**CITY OF BATON ROUGE  
PARISH OF EAST BATON ROUGE**

**ADDENDUM NO. 3**

**SUBJECT: GROOM ROAD (McHugh Road – Plank Road) PROJECT  
CITY-PARISH PROJECT NO. 19-EN-HC-0035**

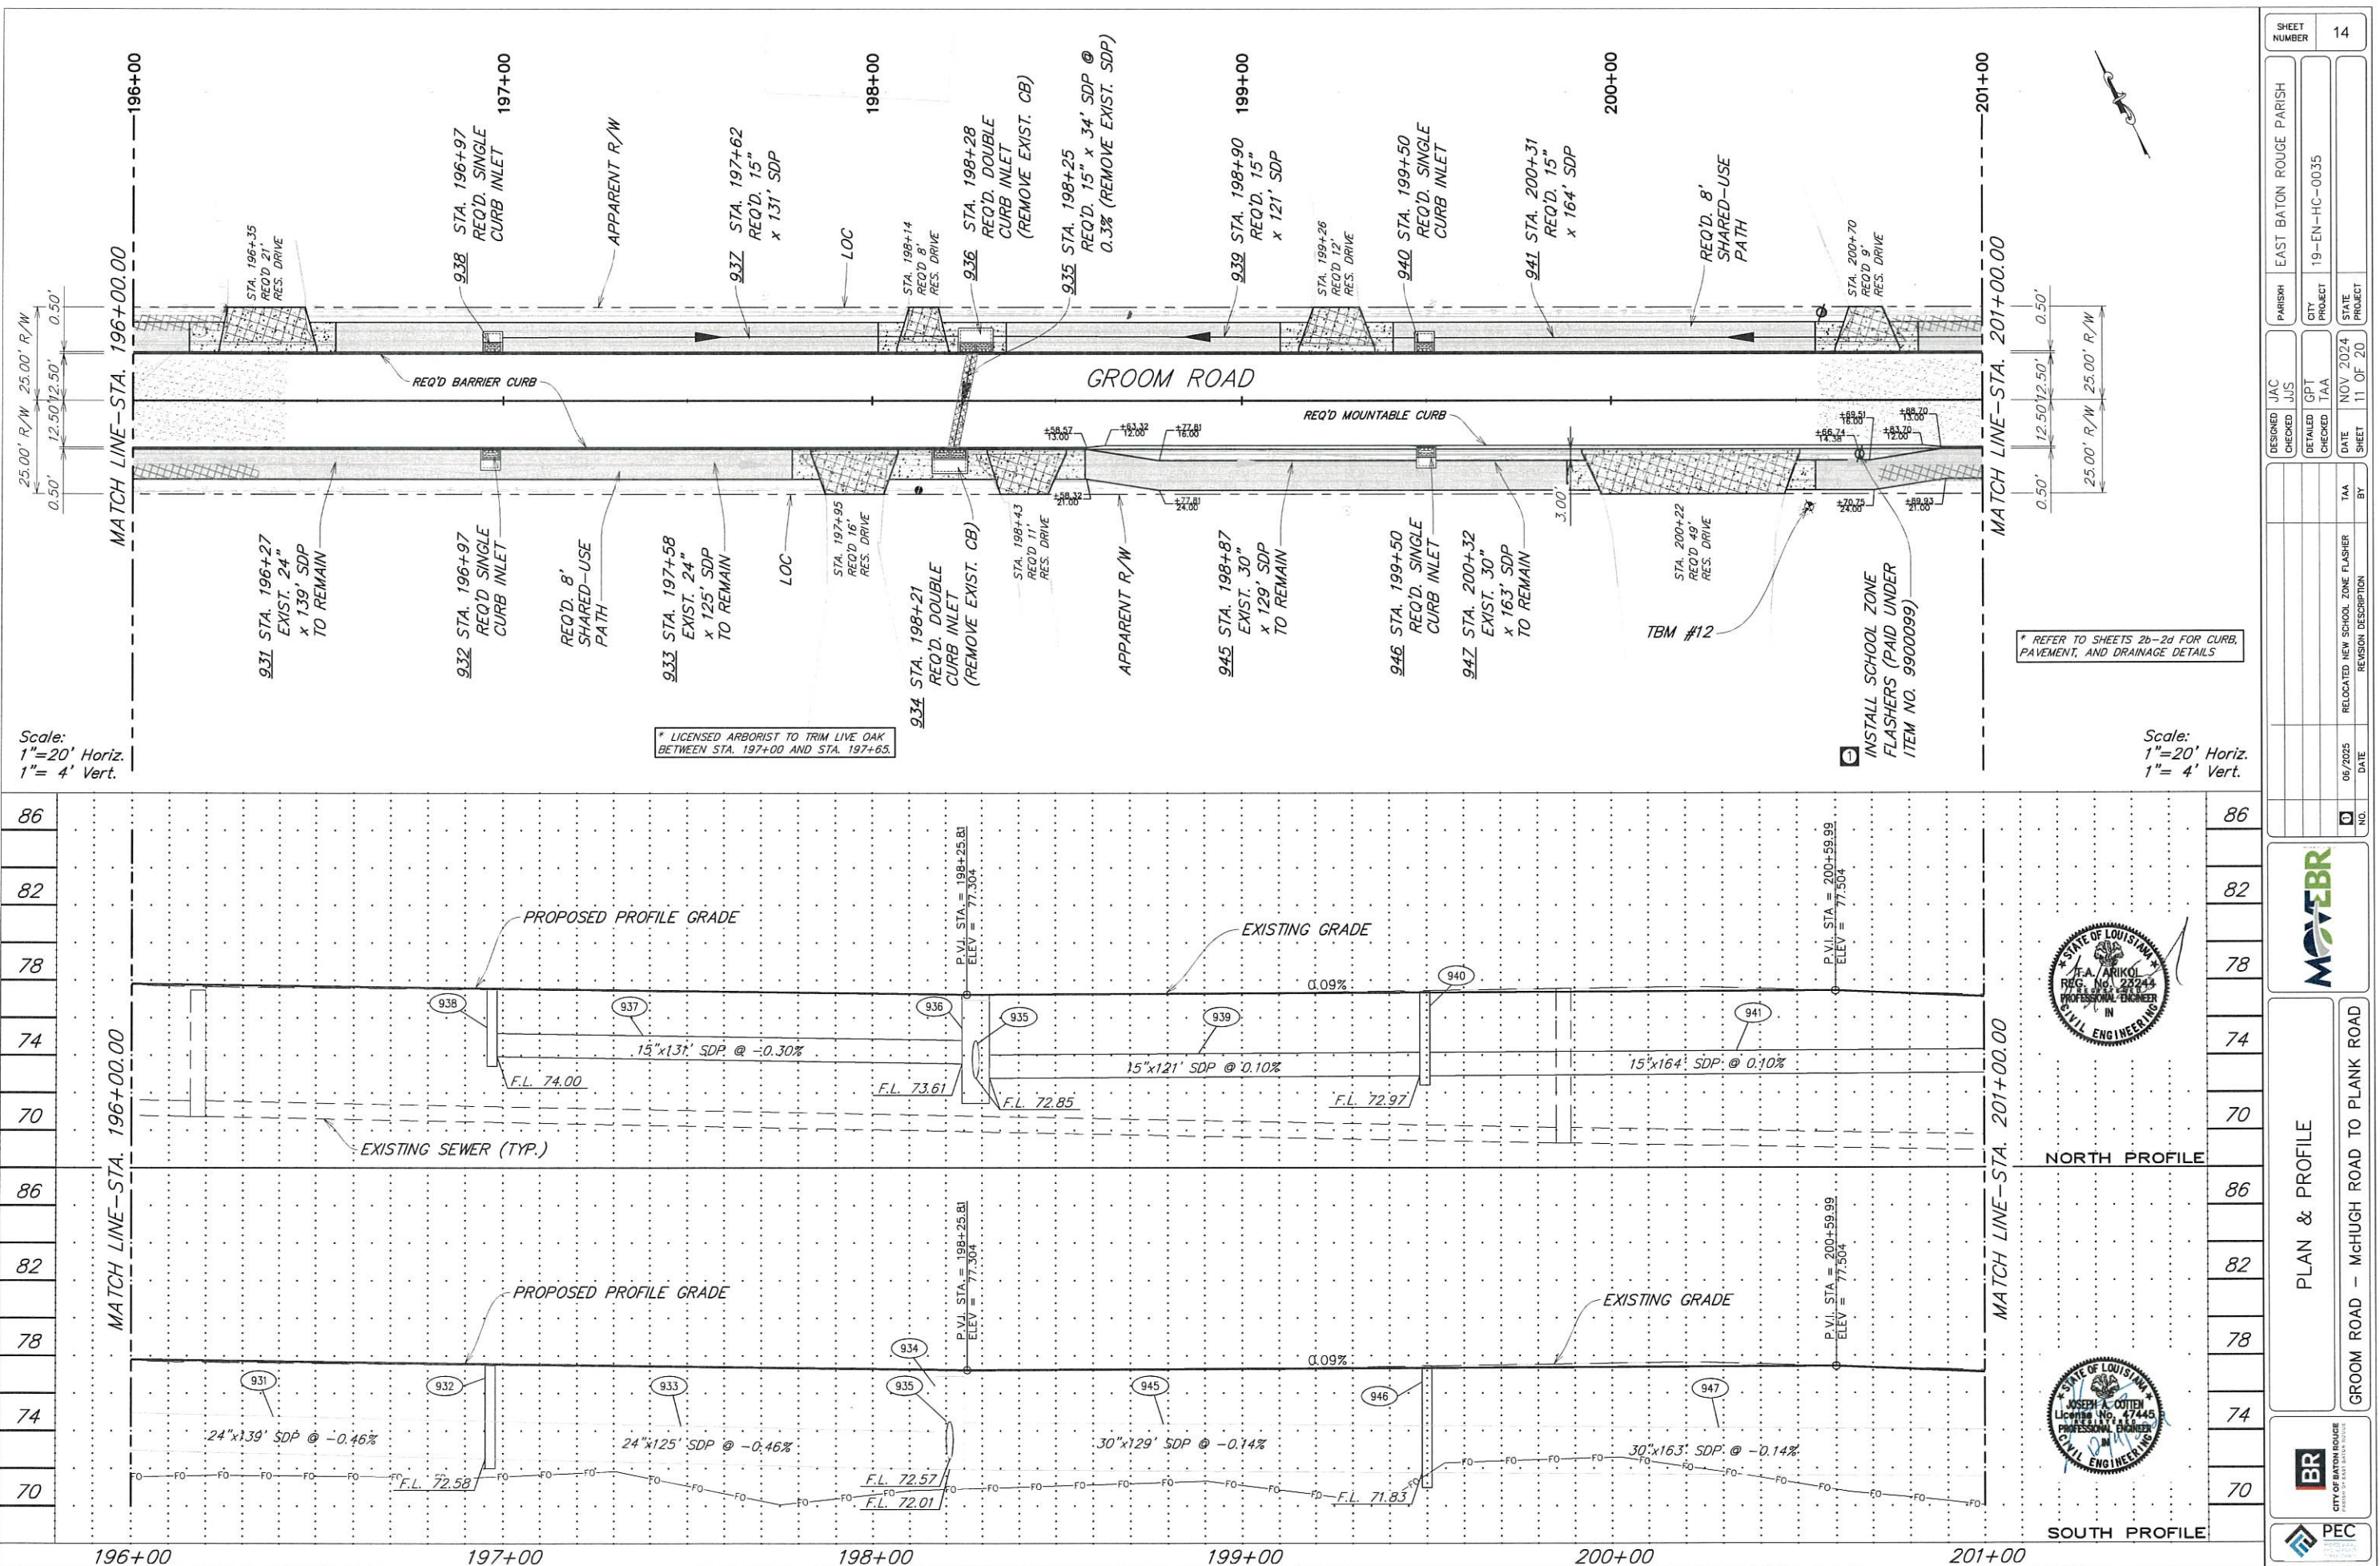
**13. Item-7020701 calls for reticuline grate, but the 702-20 plans sheet specs the Type 3 grate which is a 28" Cast Iron Grate. Please advise?**

- *This item has been revised, please refer to revised Sheet 3 and Unit Price Form included in this addendum.*

EXISTING DRAINAGE STRUCTURES

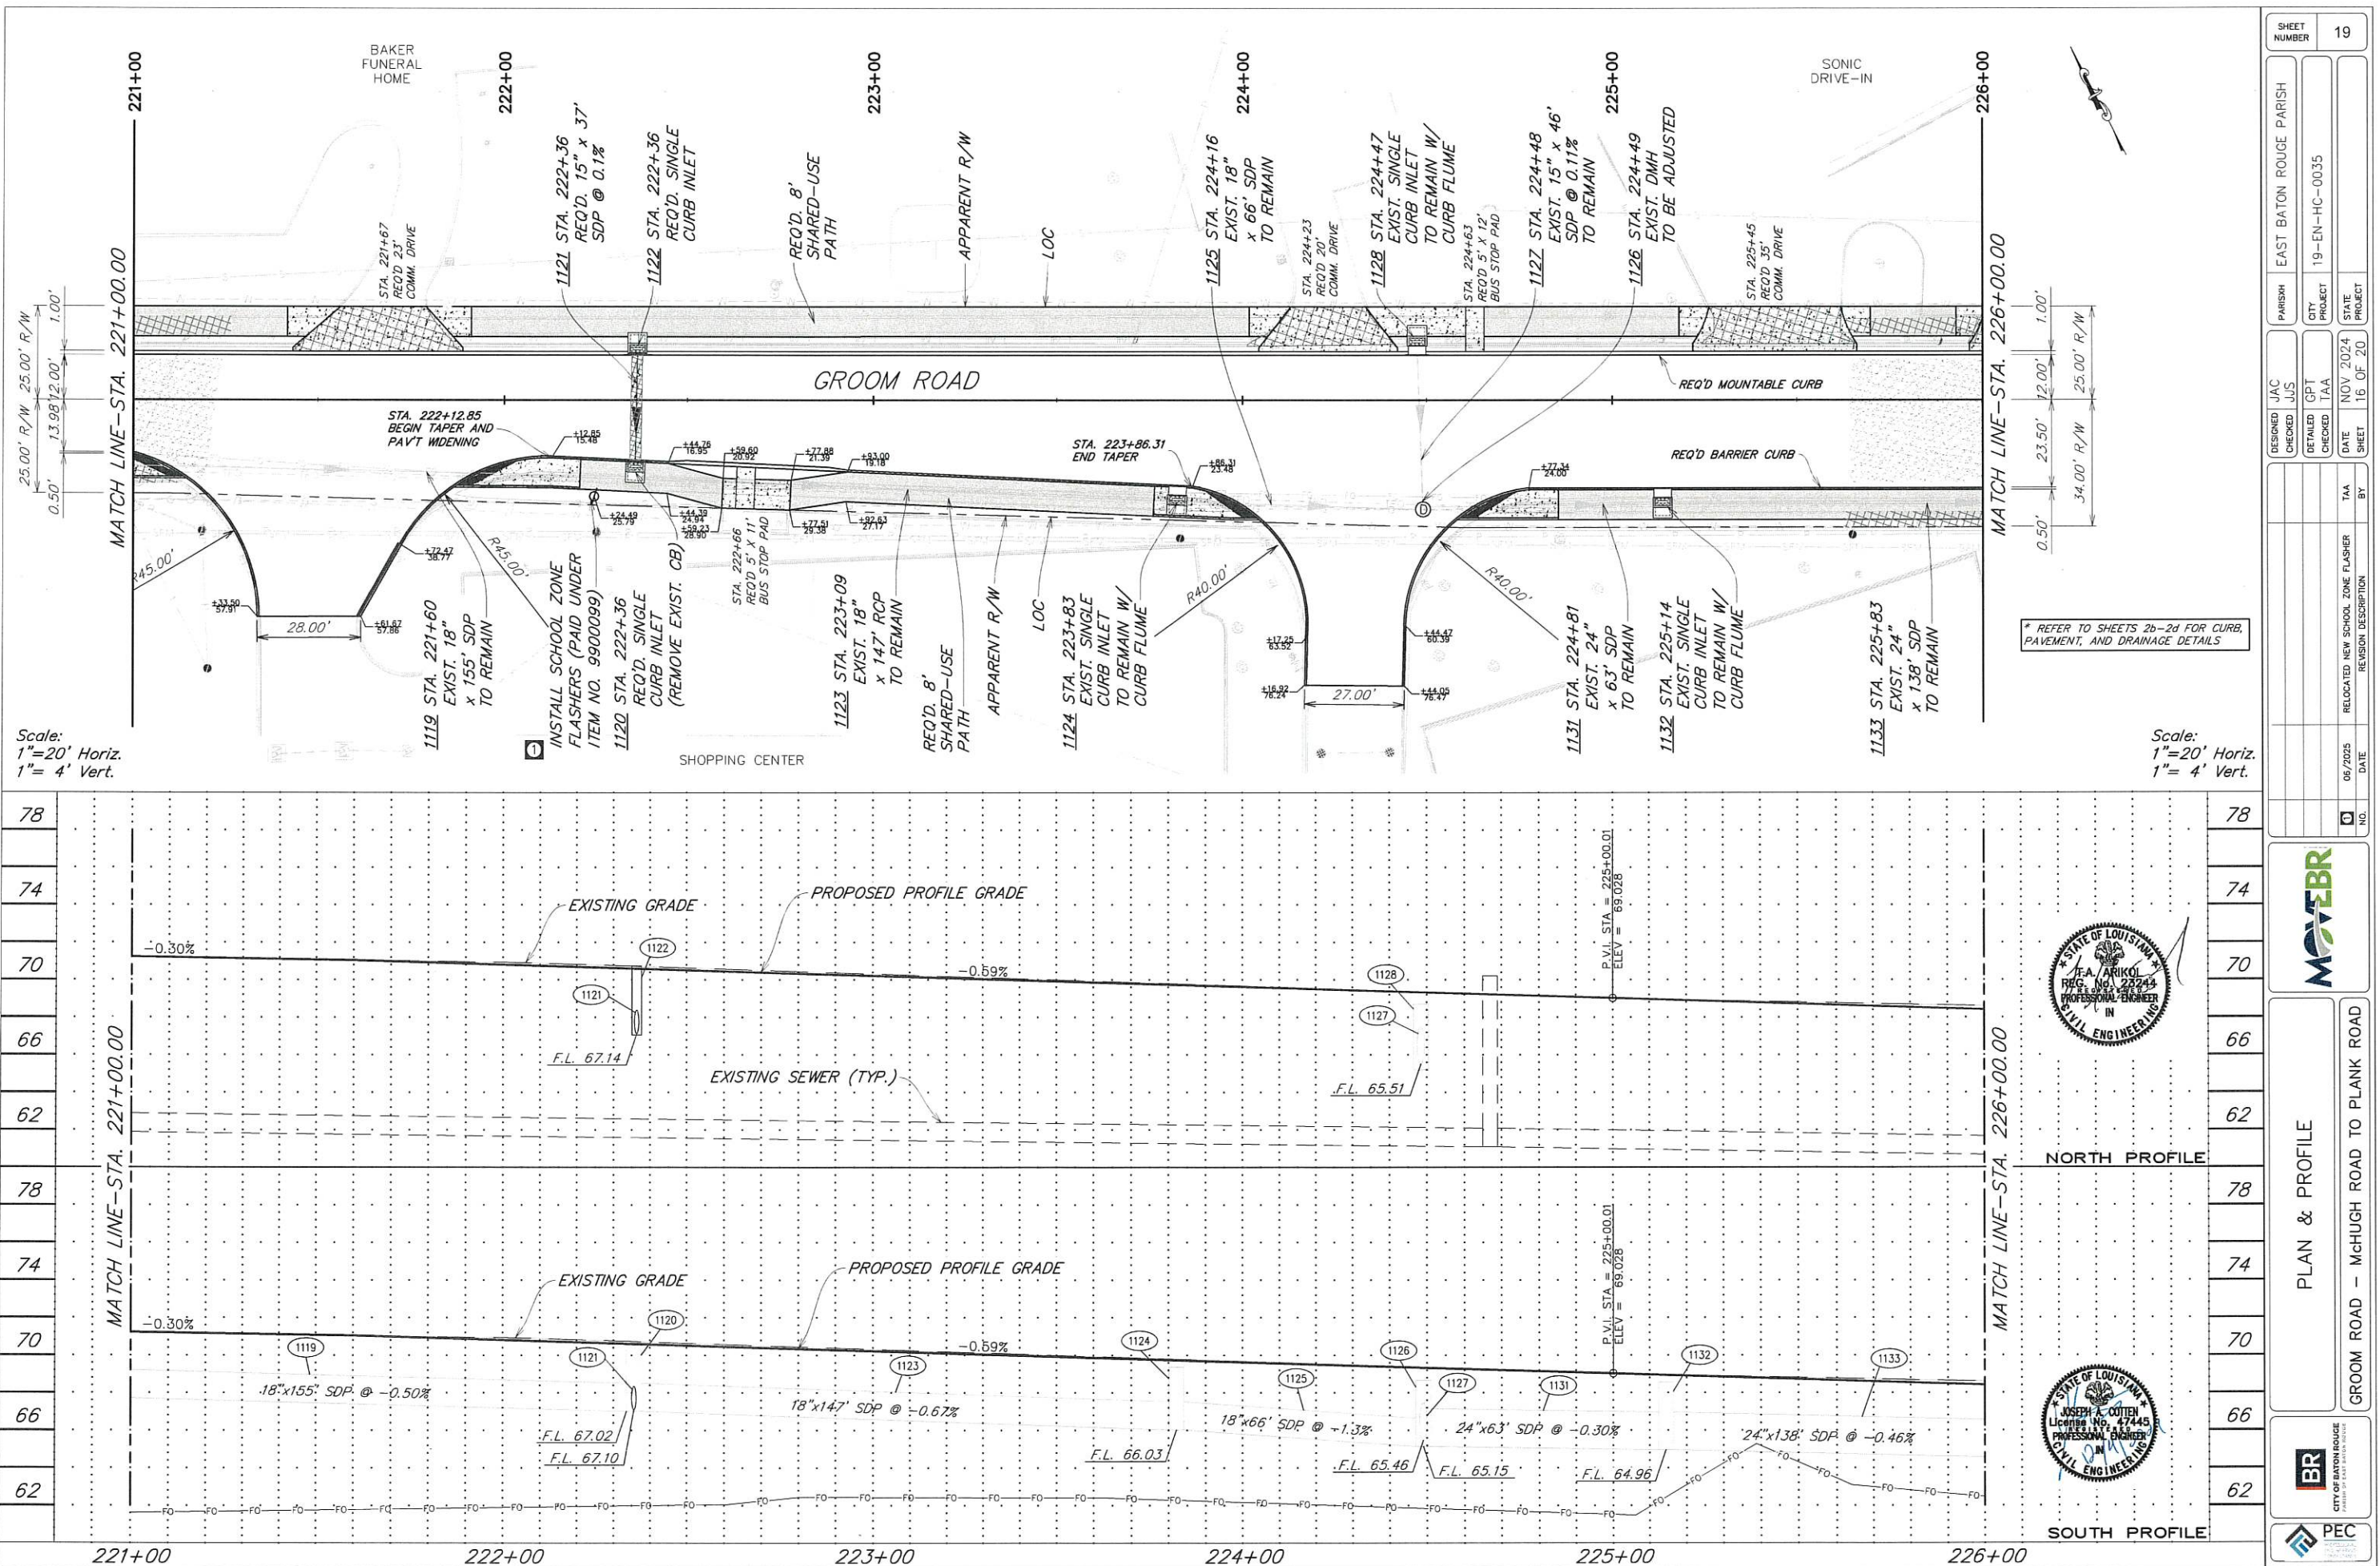
**15. The existing drainage chart on page 26 does not provide the location of the drainage pipe, and the plan and profile sheets list the pipe size. Can you provide which pipe is to be removed on the existing drainage chart?**

ADDED TO BE REMOVED COLUMN

- *Refer to revised drawing Sheet 26 included in this addendum.*

ELECTRICAL SITE PLAN - GROOM RD. ADVANTAGE CHARTER ACADEMY

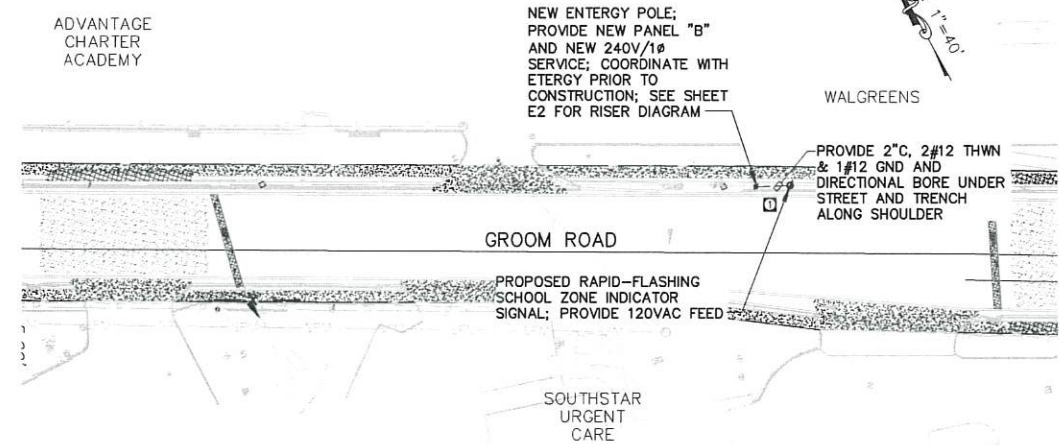
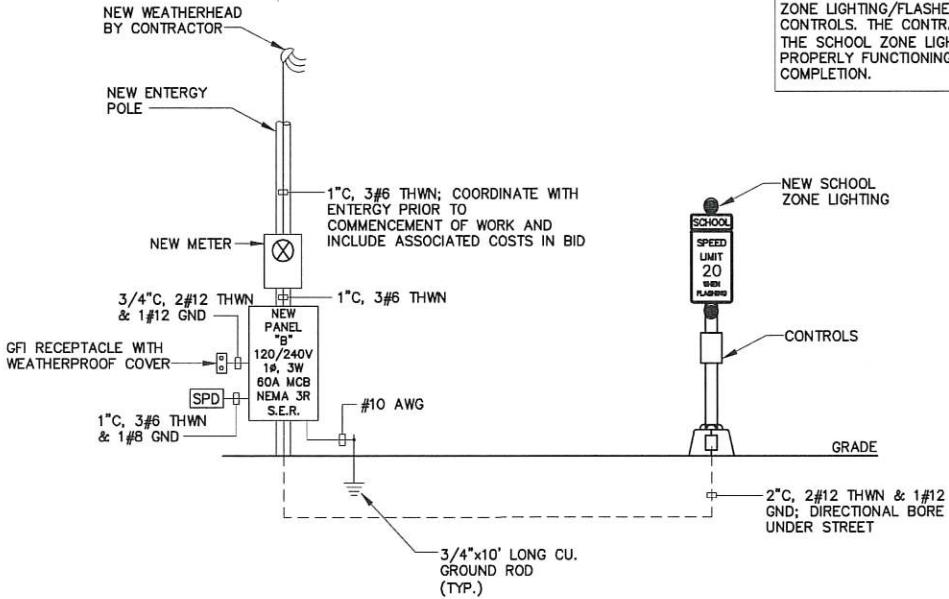
**8. The electrical drawings for the flasher only show two flashers. The way the spec reads the first item is to remove the existing and install new, and the second item is to install just the flasher. Are we installing two flashers or four as shown in the quantities?**

**9. The location of the flasher in front of Walgreens seems like it will conflict with an existing junction box. Please consider moving it if possible or we may have to remove the sidewalk and install conduit below the sidewalk then replace the sidewalk. Is there demo and replacement of sidewalk in the project?**

- *The contractor is to install 4 new flashers as labeled and described on the plan and profile sheets and the electrical drawings. One of those new flashers will replace an existing school flasher near Sta. 216+13.80. Please refer to the revised drawings included in this addendum.*

- *Please refer to revised drawings included in this addendum. The locations of 3 new school flashers have been adjusted. Yes, there is removal and replacement of existing sidewalk in the project.*

SHEET NUMBER  
E2

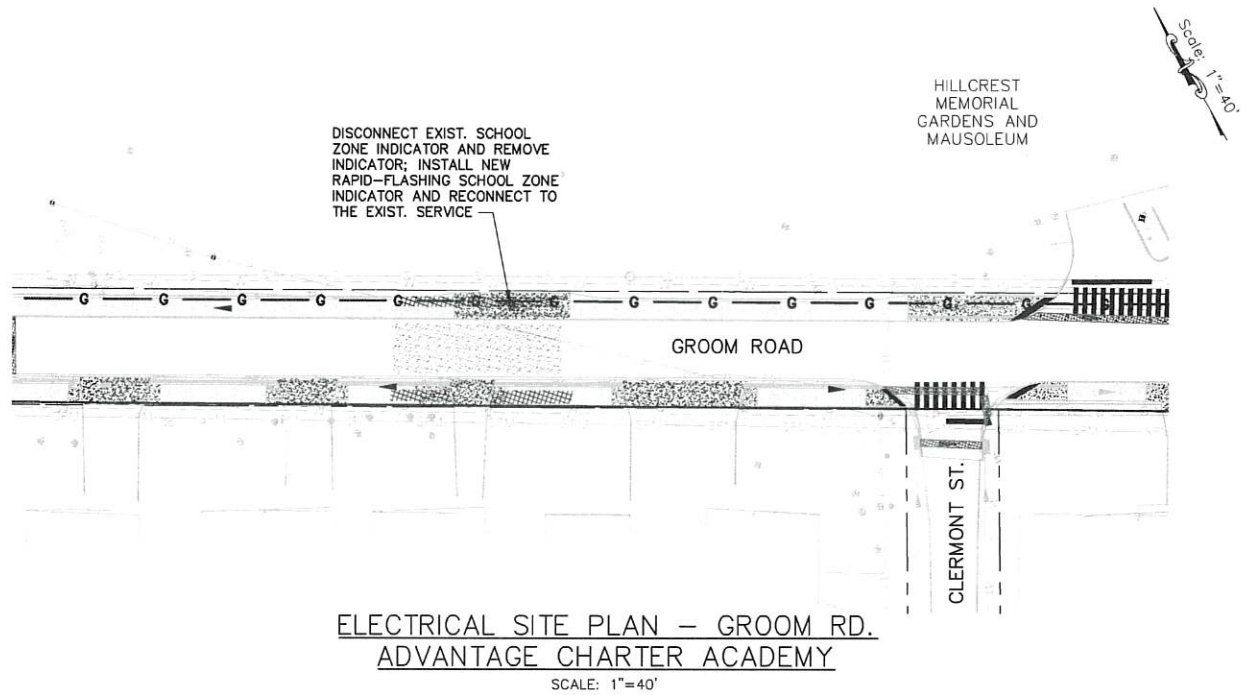
**10. Please provide additional information on the SPD required for the service of the flasher.**

UPDATED RISERS & UPDATED PANEL NAMES

- *Please refer to the revised Sheet E2 included in this addendum.*

- THE CONTRACTOR SHALL FURNISH AND INSTALL SURGE PROTECTION DEVICES (SPDS) AS SHOWN ON THESE DRAWINGS. THE SPD SHALL HAVE THE FOLLOWING CHARACTERISTICS:

1. UL 1449 LABELED WITH 200 KA SHORT CIRCUIT RATING (SCCR).
  2. UL 1449 LABELED AS TYPE 1.
  3. UL 1449 LABELED WITH 20 KA I-NOMINAL (I-N) FOR COMPLIANCE WITH UL 96A AND NFPA 780.
